**City of West Linn**  
**PRE-APPLICATION CONFERENCE MEETING**  
**SUMMARY NOTES**  
**August 1, 2013**

SUBJECT: 2-3-lot Minor Partition 1932 Sunburst Terrace. Possible lot line adjustment related to nearby property owned by applicant on Derby Street.

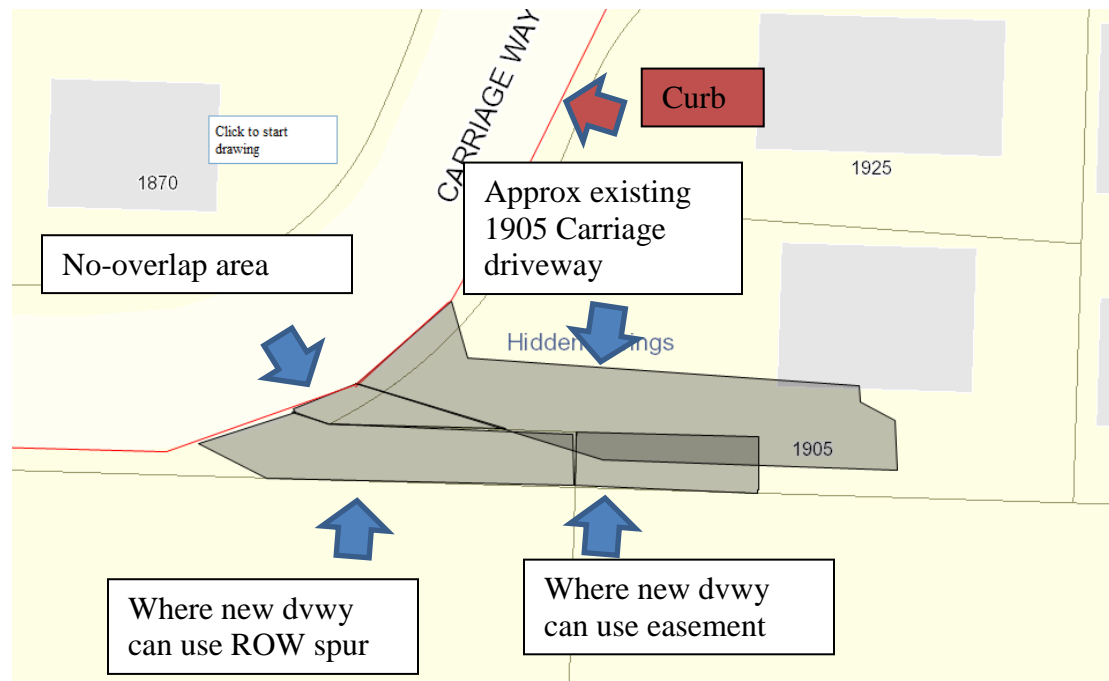
In the area before it can turn south into the site, the driveway would slightly overlap with the existing driveway for 1905 Carriage Way. A 15-foot easement is enough to access 2-4 parcels per 85.200(B)(7)(f) and 48.030(B)(2). Also 48.030(C) applies to properties where parts of a house's exterior would be at least 150 feet from the right of way. Even counting from the end of the right-of-way spur this might apply to this property when partitioned. 48.030(C)(4) requires such properties to have 20 feet of horizontal clearance in all areas for emergency vehicle access (even though only 15 are required to be within an easement).

Parts of the shared driveway further from the street would be surrounded by only the applicant's property, but areas closer to the street will have to be adjacent to areas where an extra eight or more feet of paved driveway are next to the applicant's easement, due to the existing 1905 Carriage Way driveway. In grading for the driveway, the applicant is encouraged to avoid proposing tall retaining walls as much as this is possible.

As discussed the easement and the existing driveway overlap in some areas; these are not directly adjacent to the street. 48.030(C)(4) is satisfied even in front as no trees or walls exist between the existing driveway and the right of way spur/easement. The fact that the existing driveway does not overlap at the front of the site may cause problems in meeting the access separation and curb cut separation requirements of Chapter 48. This is unless the owner of 1905 Carriage Way is cooperative with sharing an access via paving the area where the existing driveway and the proposed shared driveway would not overlap. Carriage Way is a collector street, so the minimum allowed distance between curb cuts is 75 feet per 48.060(D)(2). Also 48.025(B)(6) requires all new driveway access points meet the separation requirements in Transportation System Plan Table 8-3, which for collector streets is 150 feet between driveways. Unless it is possible to share an access for the curb cut and/or the area where the driveways do not overlap outside the easement, the applicant will likely need a Class II Variance to at least one of these requirements. To be clear the driveway separation and curb cut separation variances are two different variances from two different code sections even though they are related.

If the owner of 1905 Carriage Way is cooperative regarding the "no-overlap area" outside the easement and existing driveway shown below, combining the entrance to the driveways could avoid the above issues. However this might cause the collective curb cut for two adjacent and overlapping driveways, on the other hand, to not comply with maximum curb cut width requirements. Specifically 48.060(B) requires curb cuts to not be wider than 36 feet. So under this scenario the required Class II Variance would be from 48.060(B) instead. This scenario is preferred by Engineering to the scenario with two curb cuts, but as discussed it requires the
